# CITY OF MINNEAPOLIS SW DEIS COMMENTS

## Overview:

Figure 2.3-14. LRT Guideway – LRT 3A-1 (Co-location Alternative)  
Freight Rail South of LRT

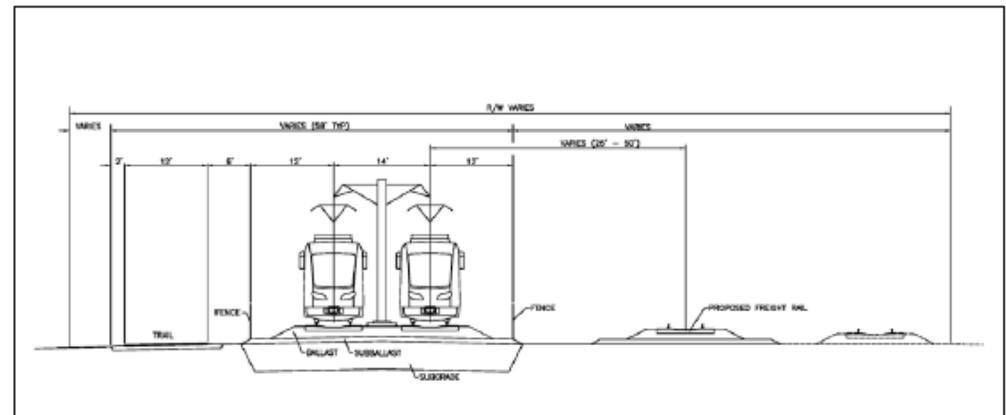
- There are massive park and residential neighborhood impacts
- Only 62 feet is available; property taking is required and is not supported by the city

## Locally Preferred Alternative Issues:

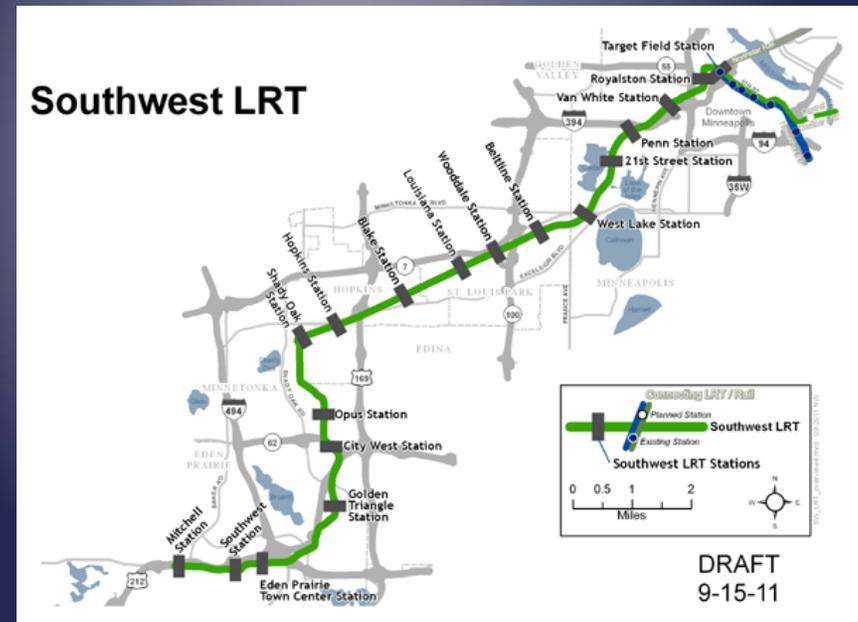
- Keep all 5 stations
- No park and rides within Minneapolis
- No additional O and M facility
- Keep the trails; rebuild them to Minneapolis design standards
- Keep the trails open for construction
- Integrate public art
- Address noise and vibration concerns

## Locally Preferred Alternative Issues:

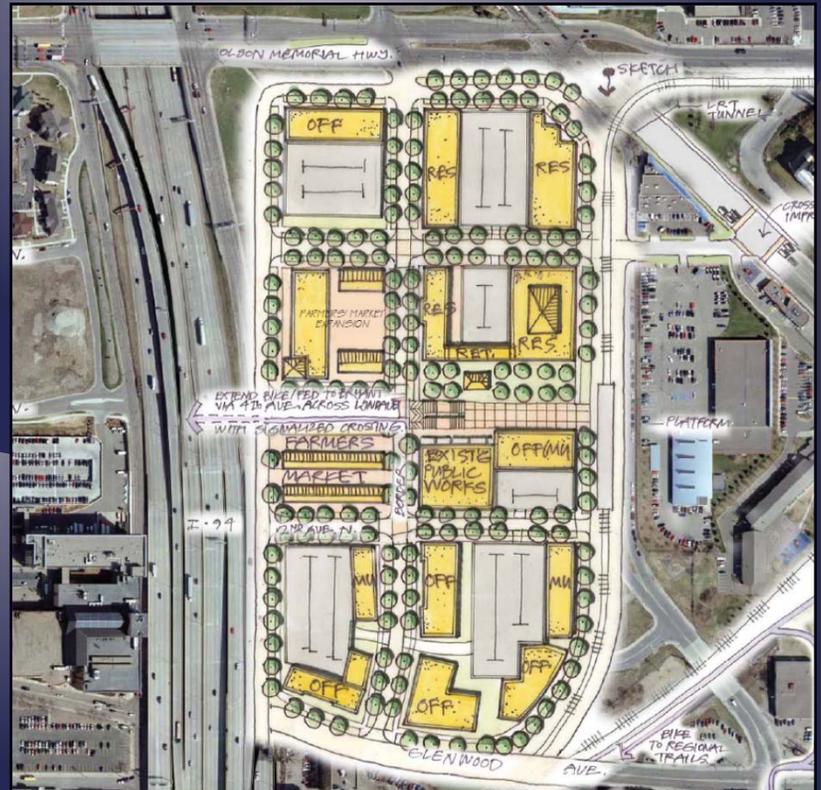
- Stormwater policies must be followed
- A tunnel will not work at 7<sup>th</sup> Street due to the Interchange project. Other options must be considered
- Traction power substations and signal bungalows must be appropriately placed and mitigated
- Concerns about grade separating Cedar Lake Road

## Lake Street Station:

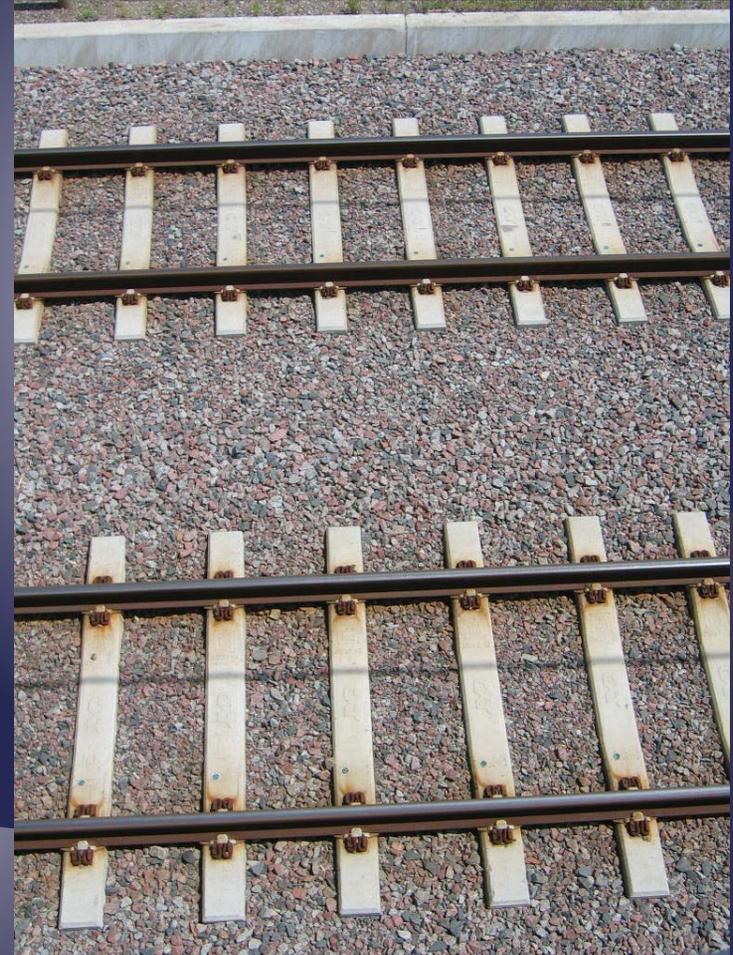
- Station placement must allow for a future streetcar to the Midtown Corridor
- Vertical circulation is required between the station platform and bridge deck
- Connecting sidewalks are needed
